SECY-91-273

Subject: REVIEW OF VENDORS' TEST PROGRAMS TO SUPPORT THE DESIGN
CERTIFICATION OF PASSIVE LIGHT WATER REACTORS

ISSUES REQUIRING VENDOR TESTING FOR AP-600 DESIGN CERTIFICATION

AP600 - PASSIVE SAFETY SYSTEMS

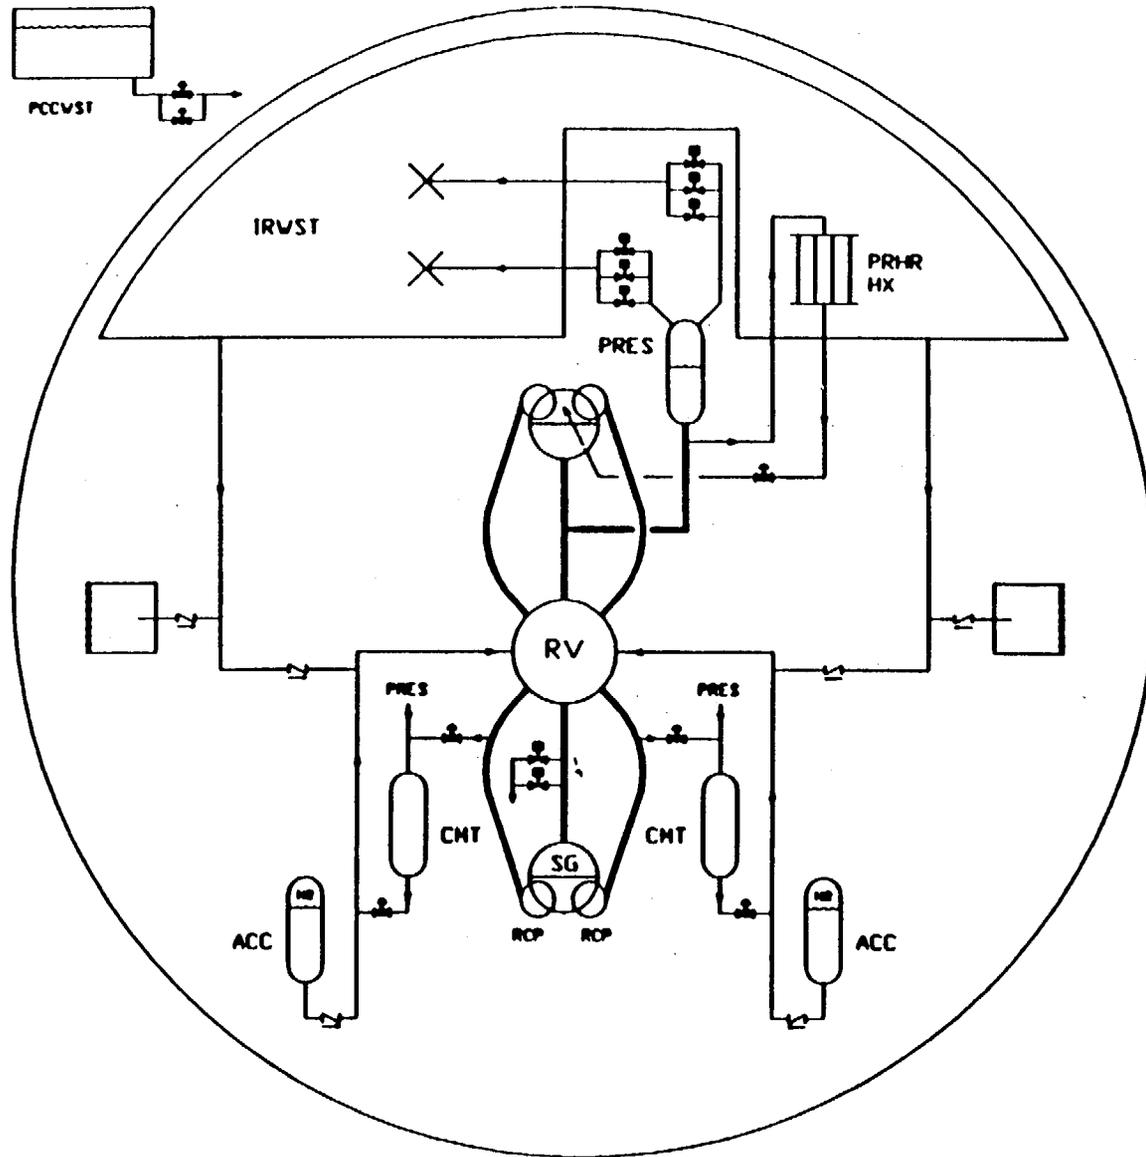
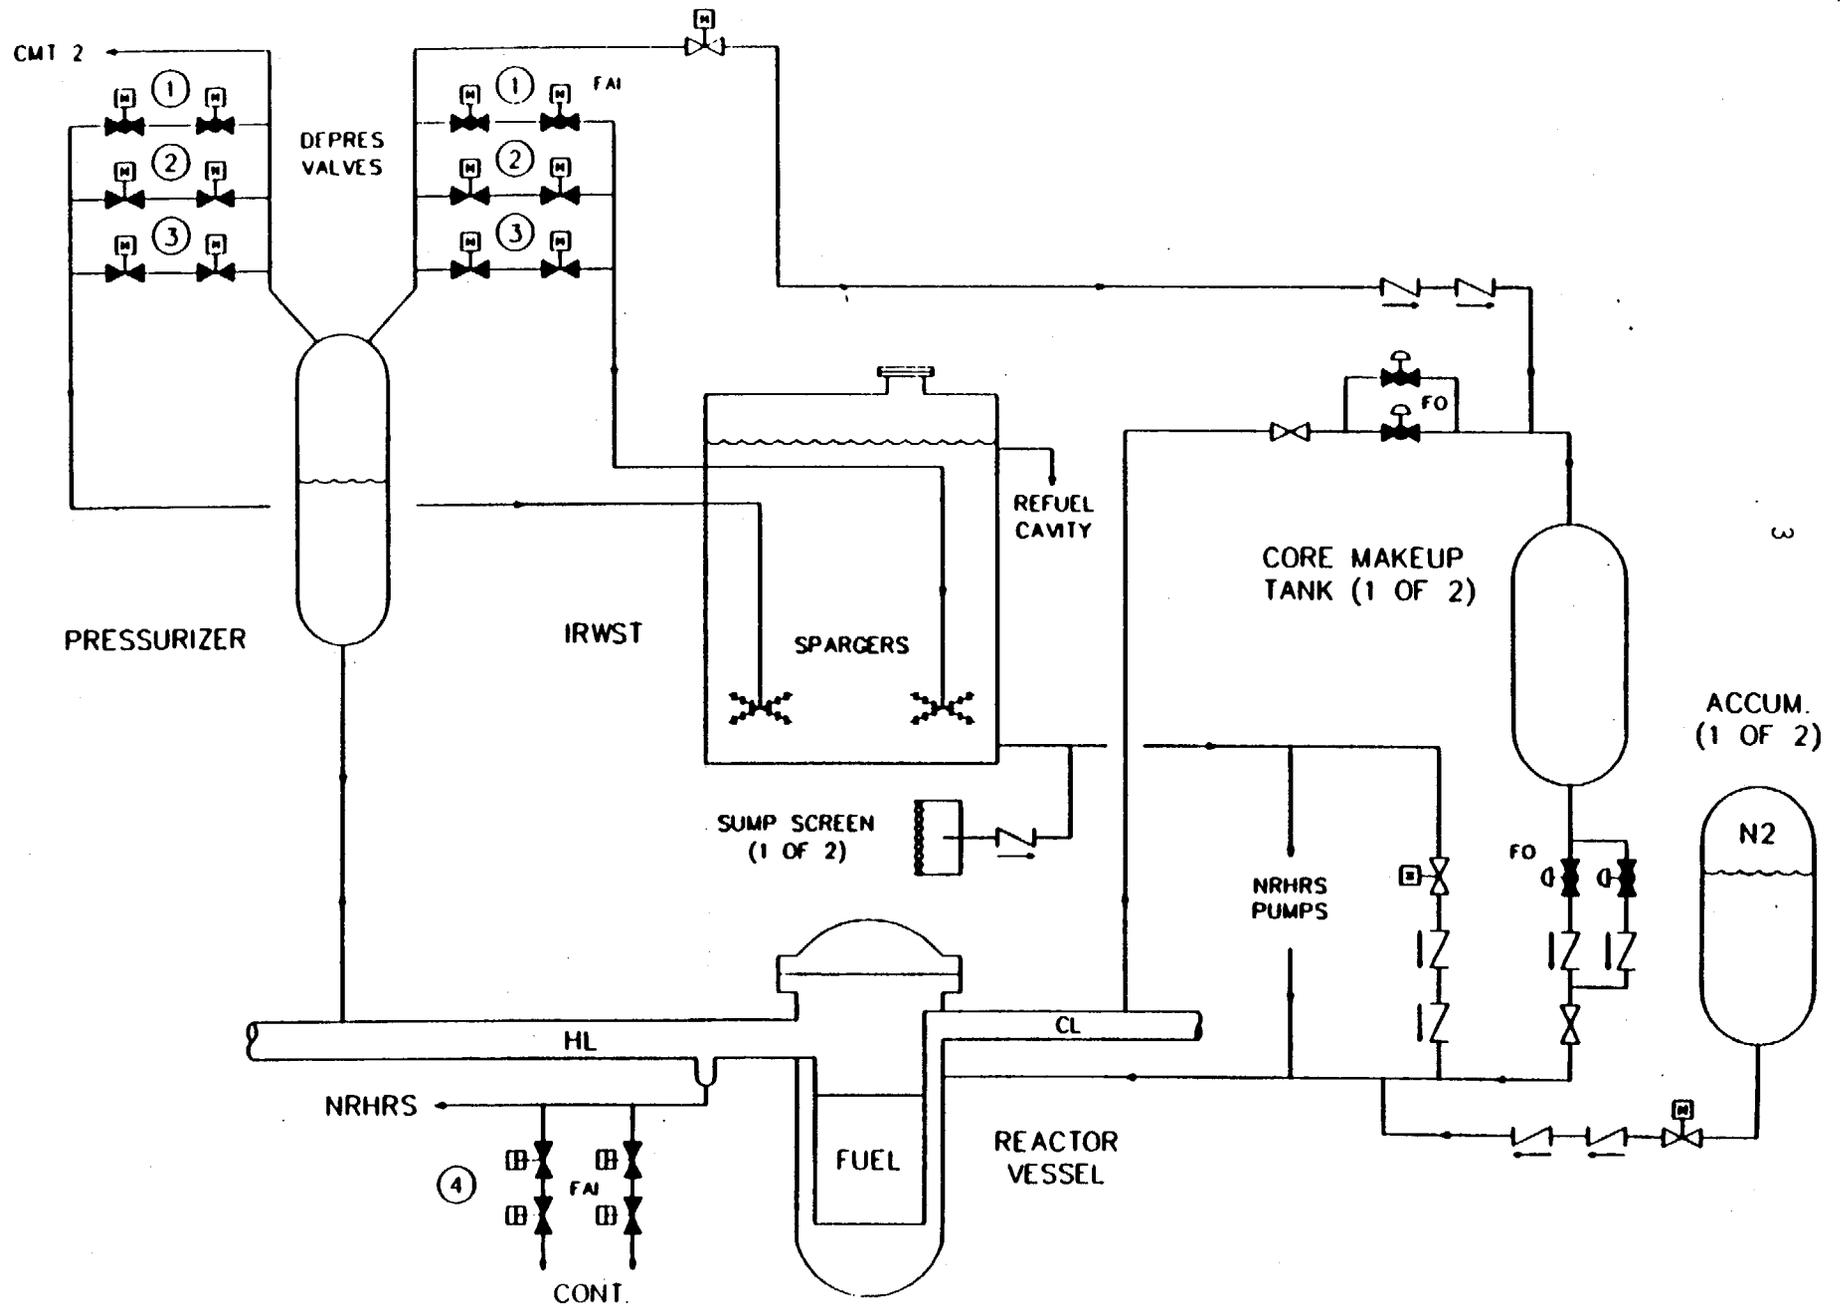
- a. There is no simulation of the pressure balancing line connected to the primary system cold leg. System interactions involving this line cannot be studied.
- b. There is little or no capability to simulate the CMT and the rest of the primary system, especially the impact of pressure oscillations due to steam condensation on injection performance.
- c. There is no simulation of ADS behavior resulting from CMT drain-down, or of the effect of system depressurization on CMT operation.

- a. No testing of the fourth stage of ADS is planned, including blowdown to a simulated containment environment. Data on critical flow under these conditions and the transition from critical to non-critical flow are needed to permit modeling of ADS behavior.

- b. Tests are planned only with steam and saturated water at the inlet of the valves. No tests are planned with a two-phase mixture at the valve inlet. The fluid conditions at the valve inlet affect its critical flow behavior, and thus the depressurization rate of the system.
- c. The Passive Residual Heat Removal Exchanger (PRHR HX, described in detail later) is also located in the IRWST. No direct testing of the impact of condensation loads during ADS operation on the PRHR HX is included.

The staff recommends that the test facility be redesigned to include the pressure balancing line from the cold leg, and that tests be included to study interactions between the components in the system. Additional tests that would examine interactions with other safety or non-safety systems could only be accomplished with an integral test facility.

The staff recommends that the vendor's test program be modified to include tests that address the above deficiencies, including simulation of the PRHR HX structure in the quench tank.

AP600 - PASSIVE RHR HX

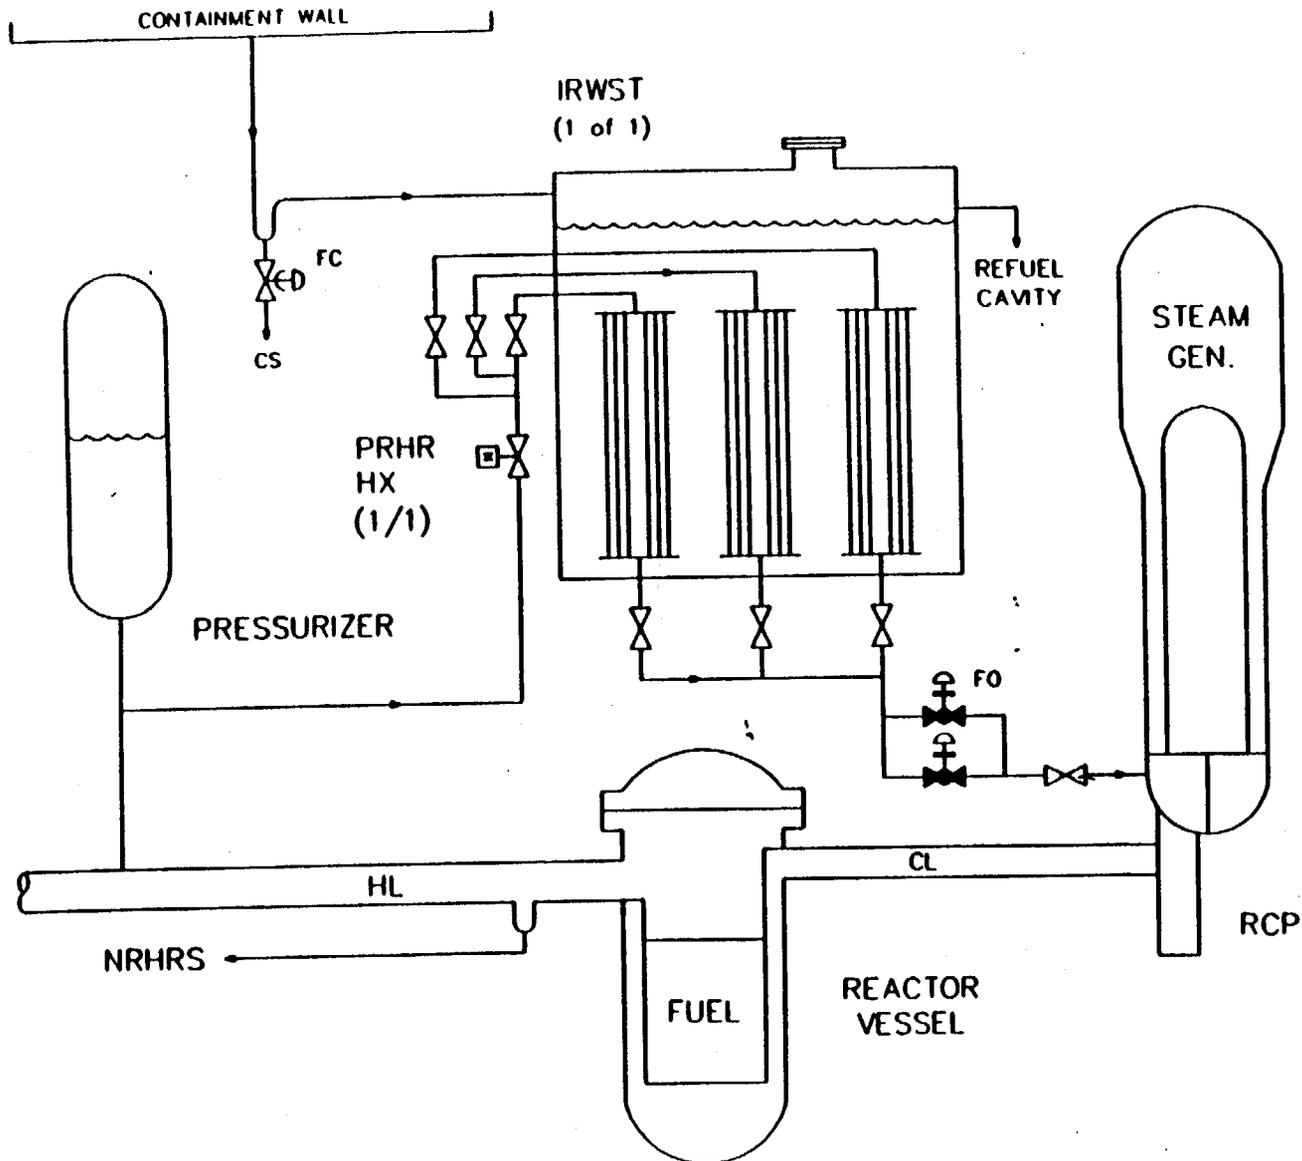
The staff has not identified specific deficiencies in the tests for this system. However, as noted above, the presence of the PRHR HX in the IRWST does raise concerns about condensation loads during ADS operation and the effect of these loads on HX performance. In addition, the actuation of the PRHR system concurrent with the first stage of ADS opens another flow path for fluid in the pressurizer, in addition to the pressure balancing line to the CMT and the ADS valves themselves. The staff believes that these interactions with other systems should be considered in the scope of other tests, such as the ADS tests described previously, or in integral systems tests, to examine thermal-hydraulic interactions with other systems.

AP600 PASSIVE SAFETY INJECTION LOCA LONG TERM

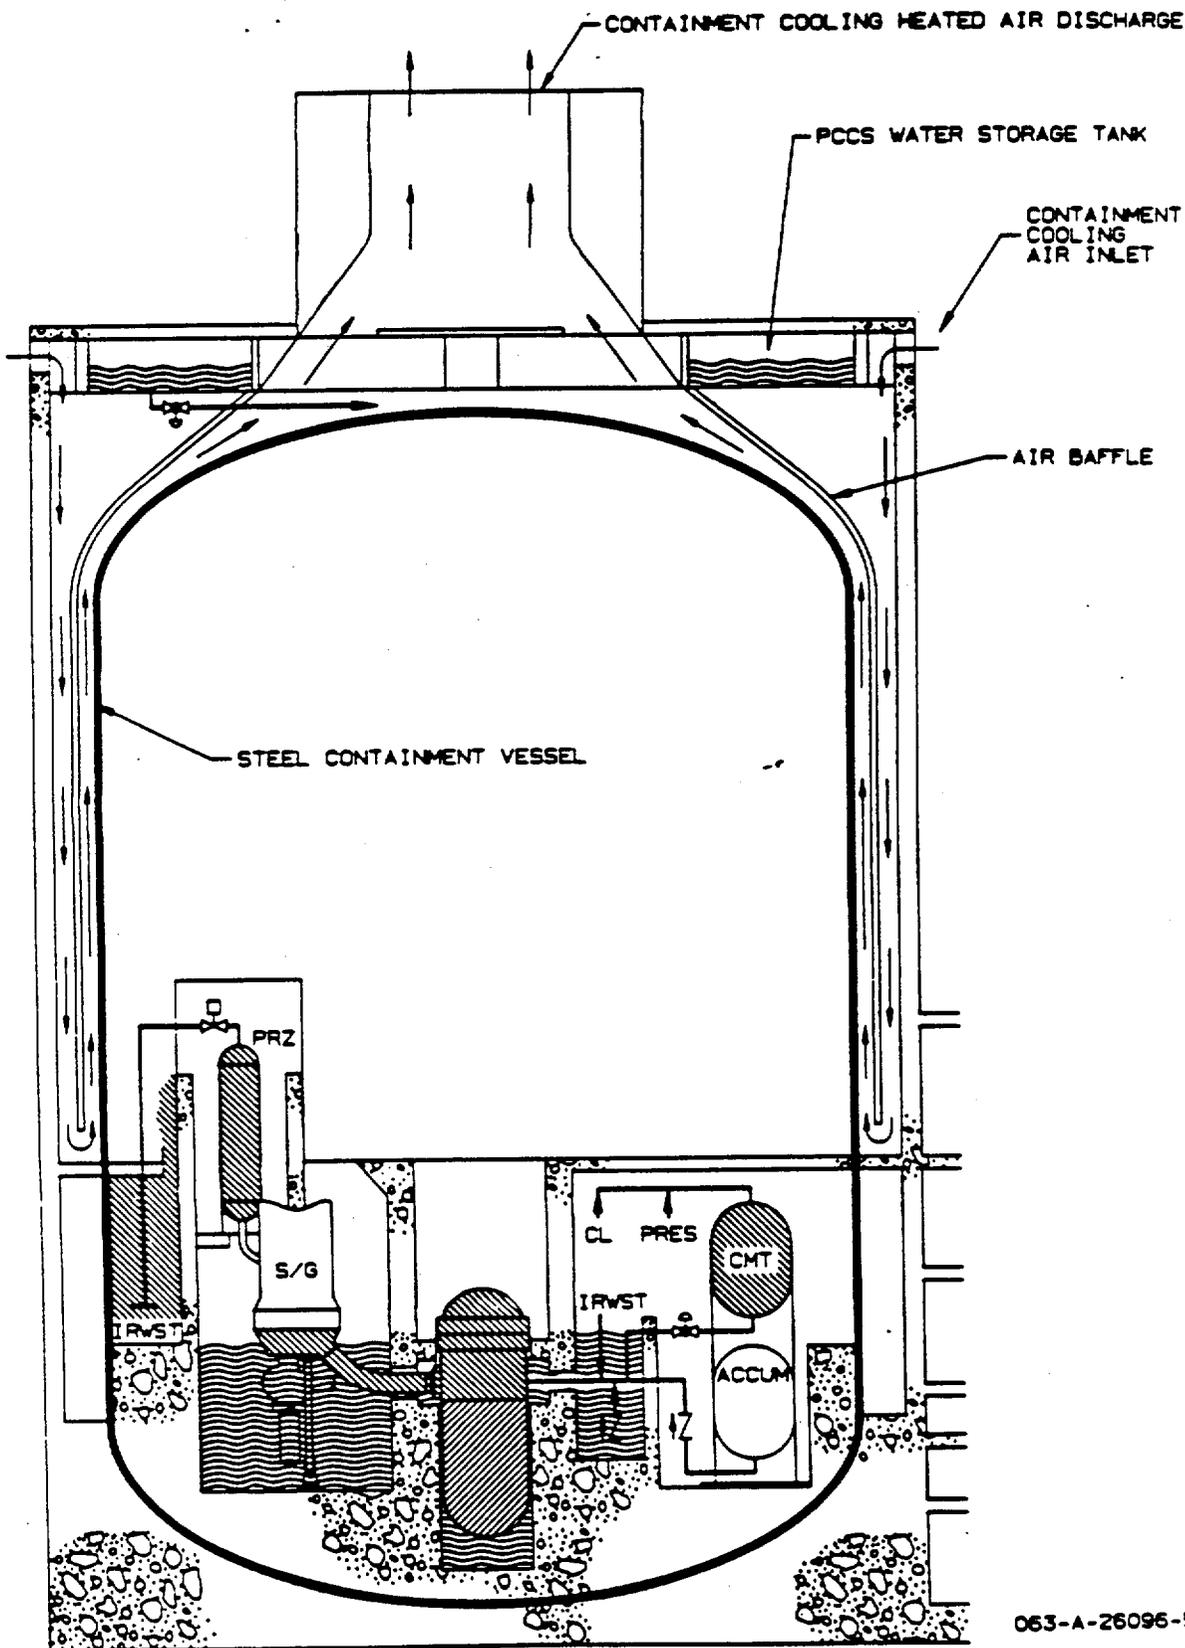
- a. The lack of a PRHR HX simulation in the IRWST is of concern. Since this component is actuated upon opening of the first stage ADS valves, it becomes an alternate flow path for fluid passing into the pressurizer. The impact of this flow path during the final stages of reactor blowdown and long-term recirculation is not clear.

- b. No means exists to simulate the effect of containment backpressure on safety system response. The interplay between containment pressure and safety system operation has been described above in the discussion on IRWST injection. The generation of steam when the RCS is at or near containment pressure could serve to pressurize the system if that steam cannot be relieved quickly. Only a small increase in pressure is required to inhibit injection from the IRWST because of the low hydrostatic head of the tank over the RCS. Interference with IRWST injection could in turn result in additional steam generation, and ultimately in core uncover, with the potential for serious damage if such a condition should persist.

The staff recommends that the facility design be modified to include a simulated PRHR HX in the IRWST. The staff further believes that the containment backpressure can be simulated by a tank connected to the RCS, in which the pressure can be varied by means of heaters and sprays. Although this would not provide a full simulation of the containment feedback on safety system performance, it would allow sensitivity studies to be conducted over a range of simulated containment backpressures. For example, the driving potential between the IRWST and the RCS can be reduced when there is significant condensation in the containment. Adequate injection flow under such adverse conditions should be verified.
